# Common Mode and Common Mode to Differential conversion specifications in P802.3bj Draft 2.0

May 13, 2013

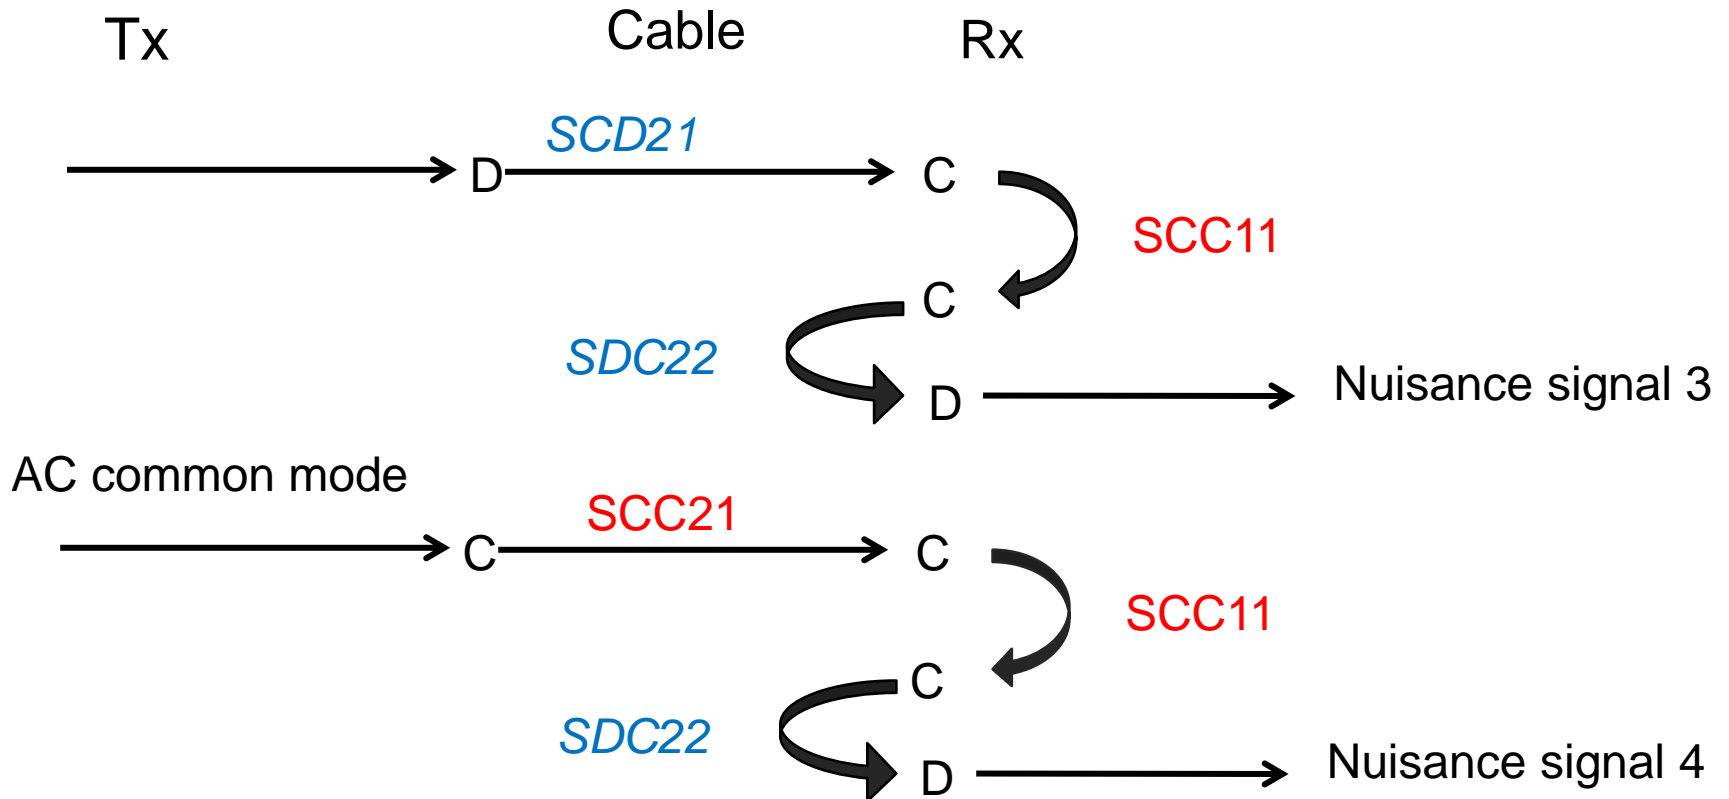
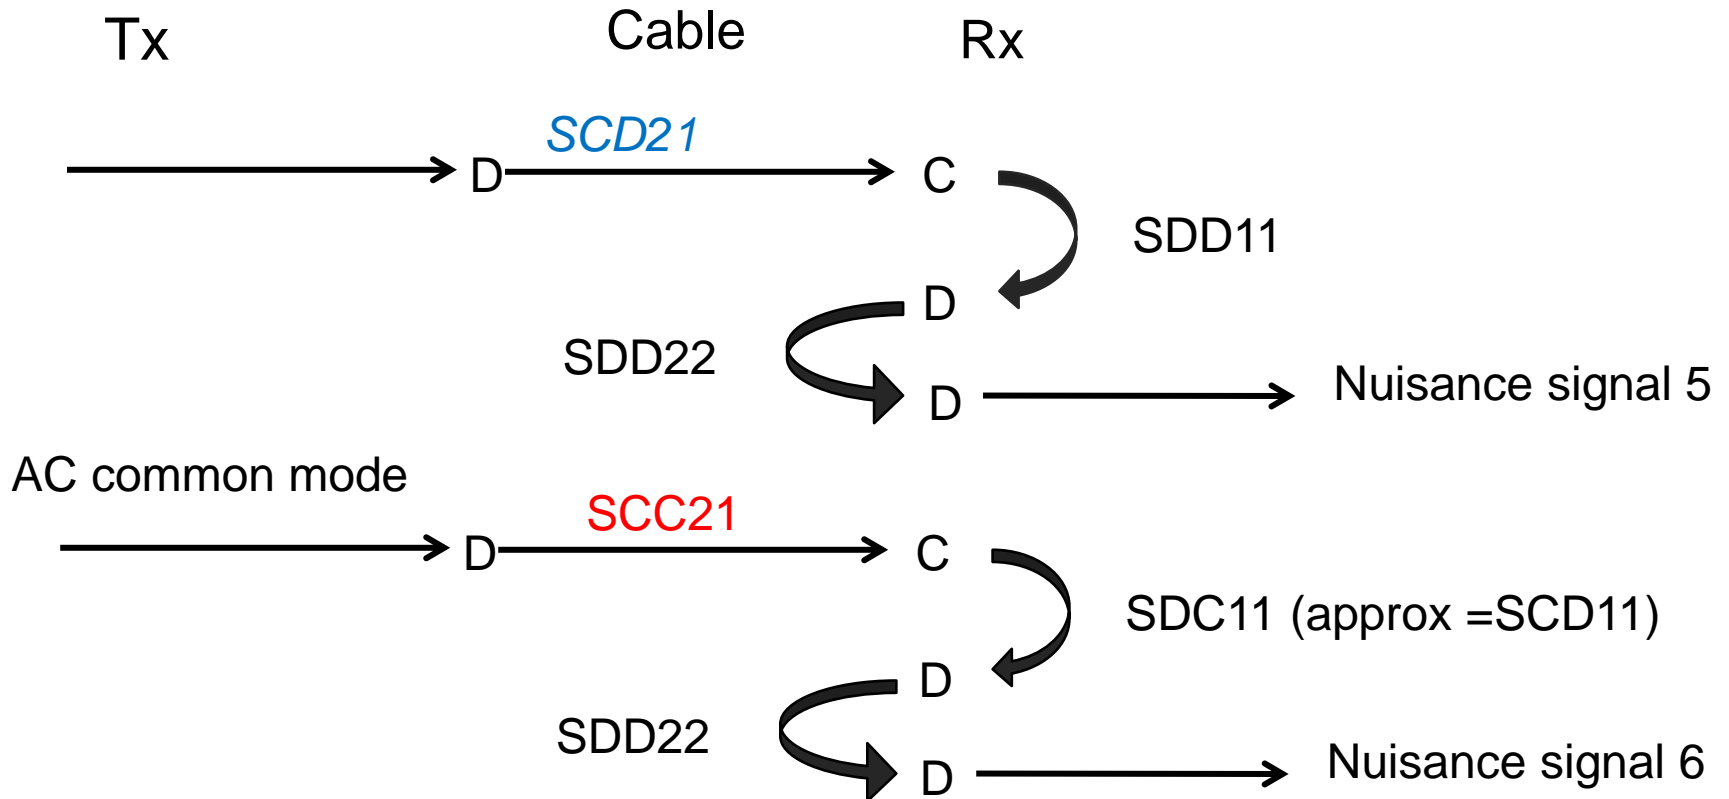
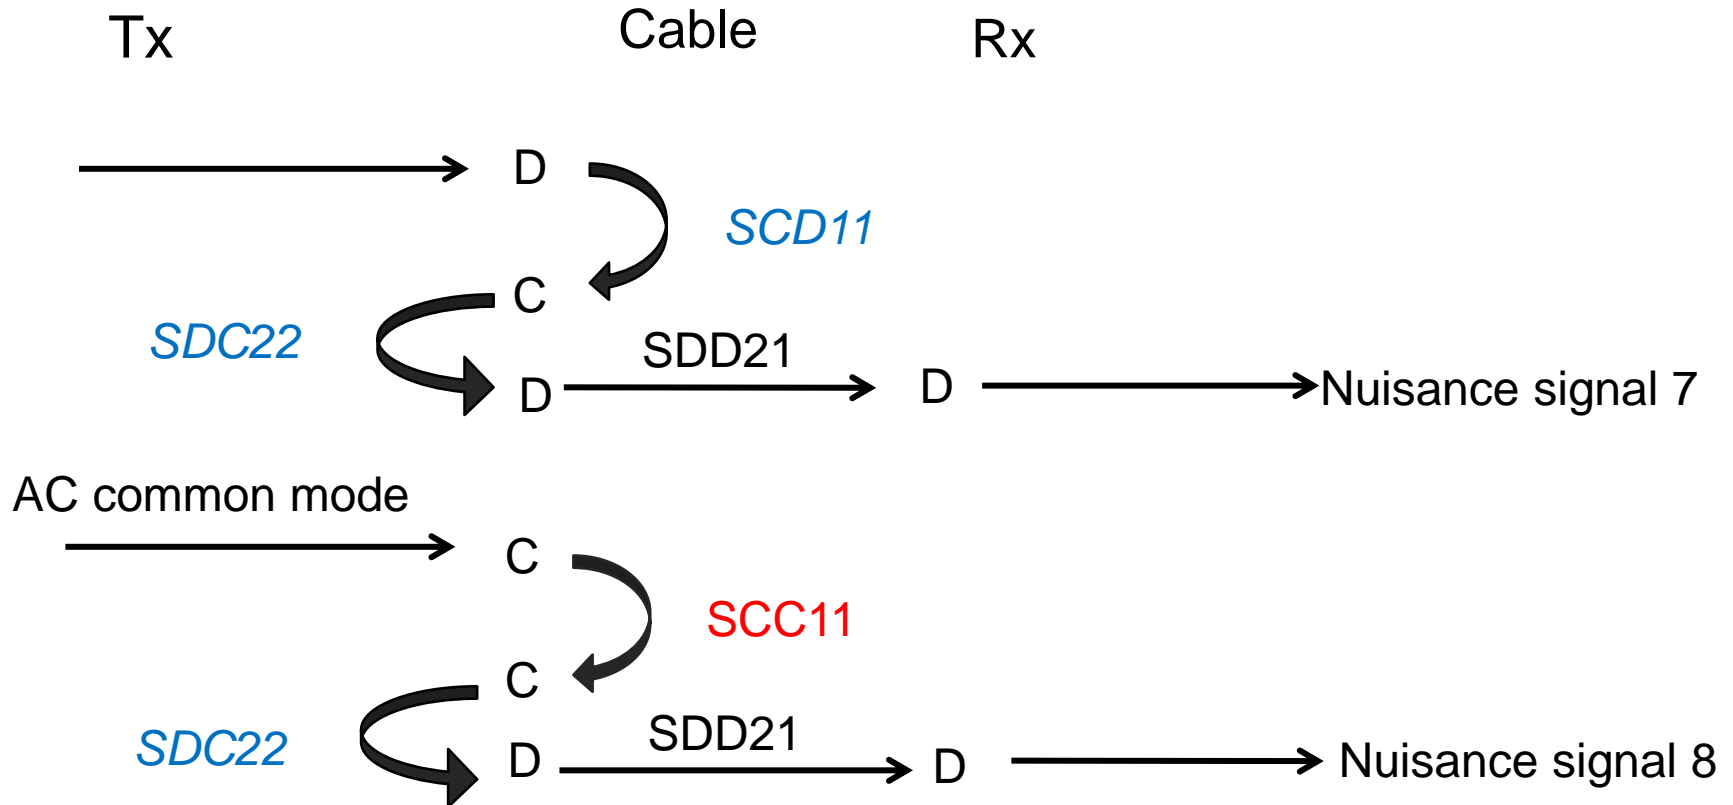
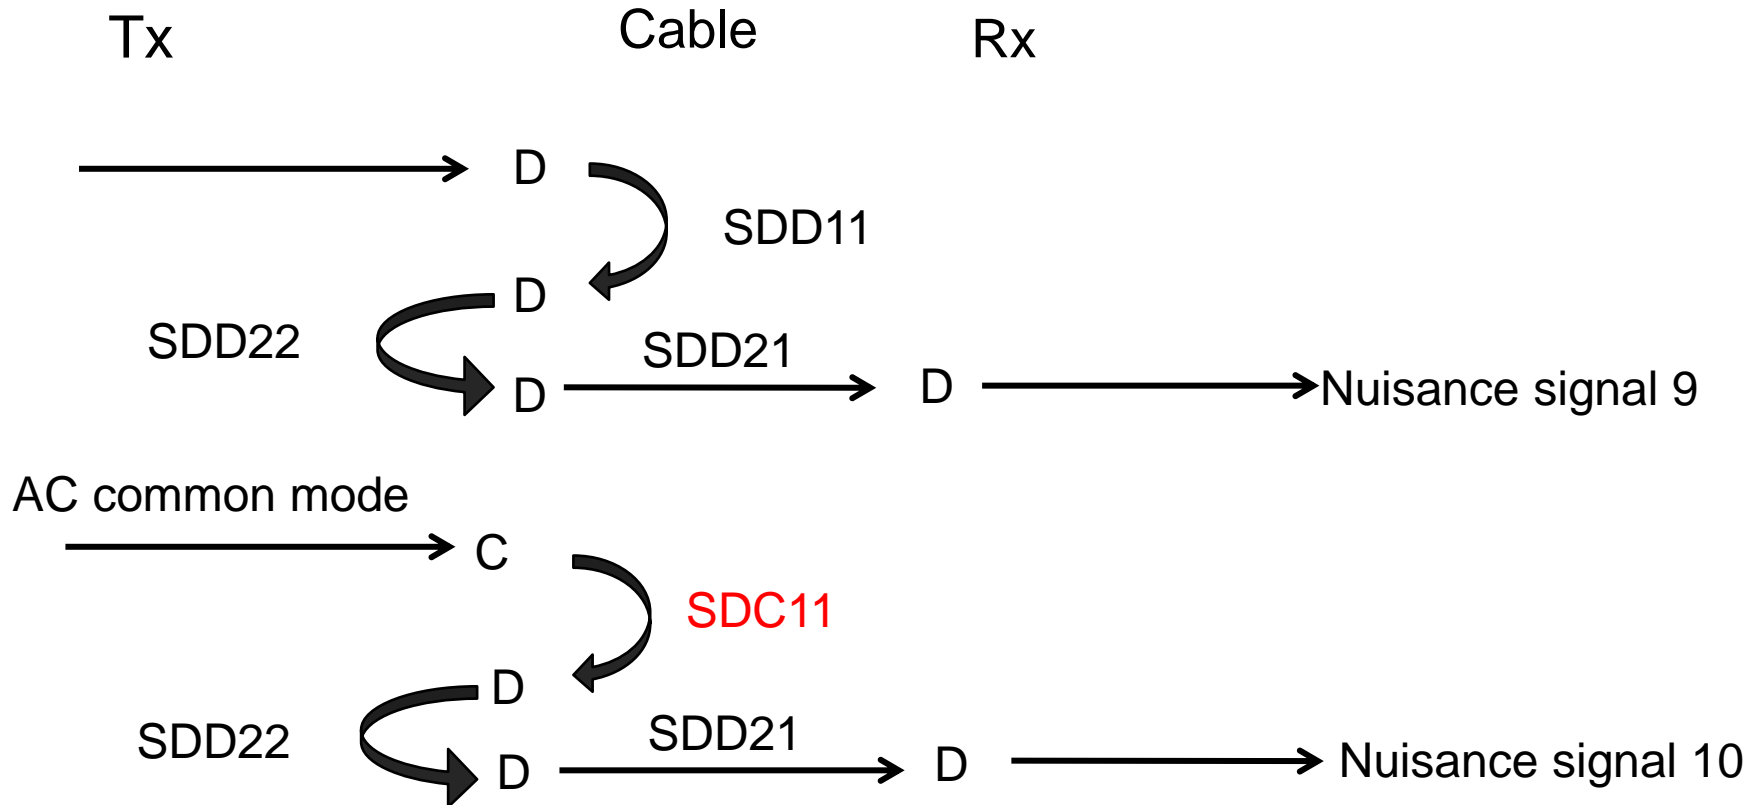
**RED** or **Blue** indicate no spec in Draft 2.0

- Add SDC22 specification to the host Tx. Suggest make 3db more relaxed than SCD11 for host Rx. (comment 186)
- Add SCD11/22 specifications for the cable. Suggest make these the same as the SCD11 specification of the host.
- Add SCD21 specification for the cable suggest SDD21 – 10 dB. (i.e. 10 dB lower signal than the through loss.) (comment 186 but better proposed solution)

# Compliance boards (test fixtures) need to be better than product

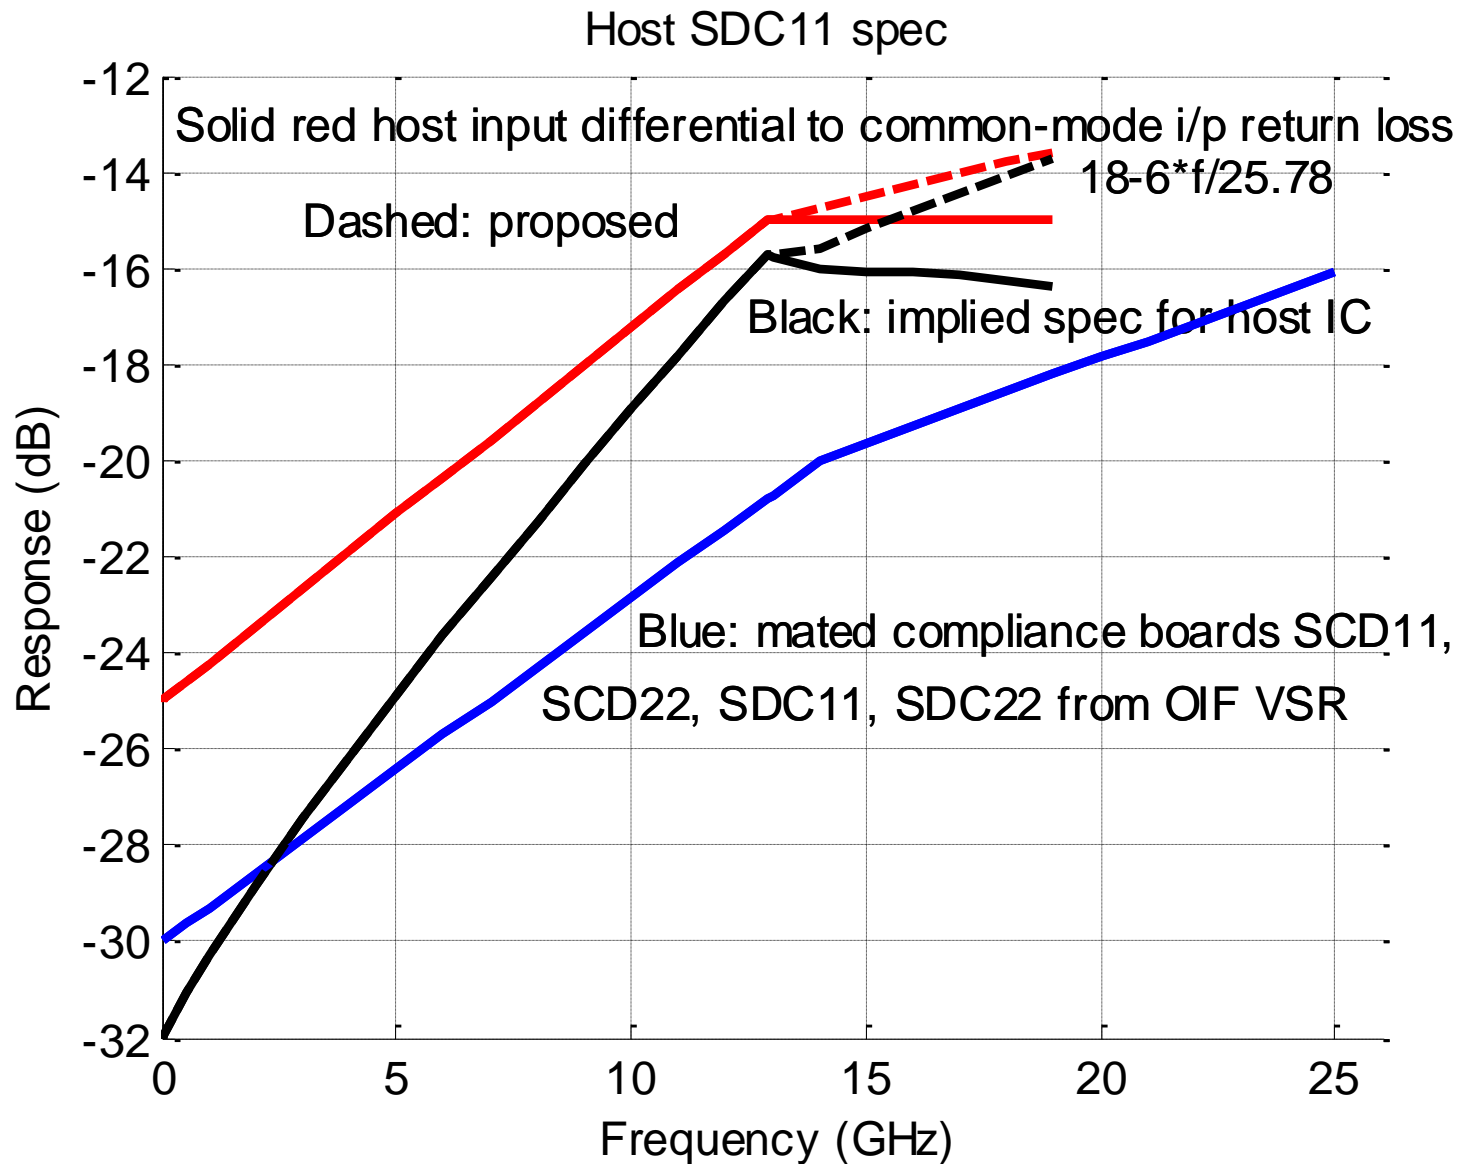
- Draft 2.0 has a spec for host input differential to common-mode return loss
  - 92.8.4.2, Eqn 92-6 (and a conflict in Table 92-8 that should be resolved. (comment 184 and 238)
- OIF VSR has a specification for the compliance board (TP2 or TP3 test fixture) below which was based on measurements of compliance boards. Recommend we add this to 802.3bj. (comment 187 and 236)

- However Host Eqn 92-6 must have a specification significantly relaxed compared with that of the Compliance Board
  - Product has to fit in the difference between the two specs
  - Therefore propose that Eqn 92-6 above Nyquist is changed from 15 to  $18 - 6*f/25.78$  (comments 187)

$$\text{HCB-MCB SCD11,SCD22 and SDC11,SDC22} \leq -30+(5/7)f \text{ dB for } f < 14 \text{ GHz} \quad (13-11)$$

$$\text{HCB-MCB SCD11,SCD22 and SDC11,SDC22} \leq -25+(5/14)f \text{ dB for } 14 \text{ GHz} < f < 28.1 \text{ GHz}$$
